NOTICE OF DECISION

ADMINISTRATIVE SITE DEVELOPMENT PERMIT 141 Front Street Expansion

APPLICATION NO: ASDP16-00002

Project name: 141 Front Street Expansion

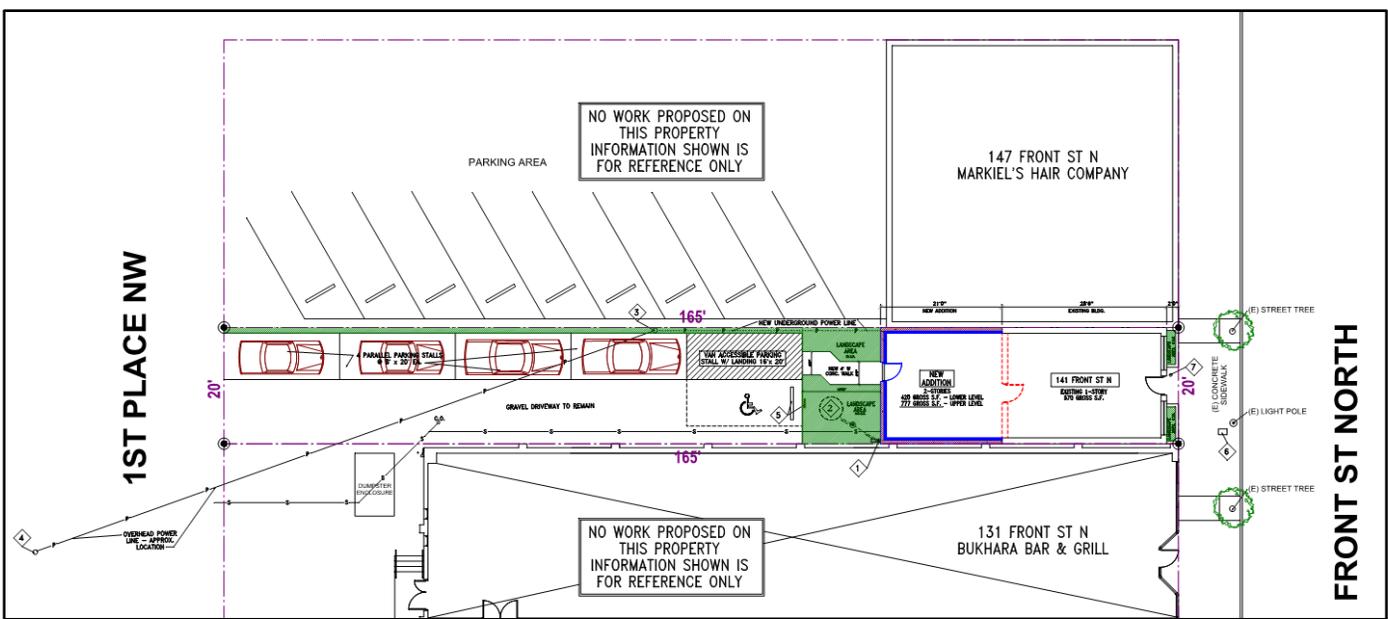
Findings of Fact: The proposed parking configuration consists of 4 parallel stalls aligned along the northern half of the property and one ADA parking stall near the rear building entry (see Site Plan, sheet A2 of Attachment 3)

Staff Analysis: With a gross building area of 1767 s.f. , the project is required to provide 5.89 parking spaces. With the allowed reduction of 15% in the CBD, the total required is 5 off-street parking spaces. The project proposes 5 parking spaces, one of which is to meet the ADA handicap parking space requirement. Fig. __ shows the off-street parking lay-out on site. The parking in the rear of the lot is consistent with the Olde Town Design Standards requirements for parking and driveway location. The parallel parking configuration is the only option available for this site due to the narrow width of the lot. The proposed vehicular access to the lot, using 1st Ave. NW, is consistent with the adjacent properties.

The Applicant has applied for an Administrative Adjustment of Standards (AAS) for the parking space dimension, to use the Central Issaquah Development Standards dimension for a parallel stall, at 8' by 20', instead of the IMC standard of 8' by 23'. The AAS has been approved and staff determination for approval is contained in the Notice of Decision (see Attachment 3).
